## Access Compliance Report Public Rights-of-Way (Curb Ramps)

Intersection ID: 23936 Main Street: CANDLEWYCK\_LN Cross Street: LAWTON BLUFF RD Location: SE

ADA ID: 43EC9A9C0BDA Ramp Type: PerpDiag Initial Pass/Fail: Fail Overall Compliance: No Severity Score: 21.25

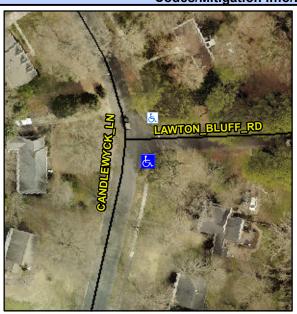
Not Found, R304.5.1, R304.2.2

Remove & Replace Curb Ramp With Two New Directional Ramps or Equivalent.
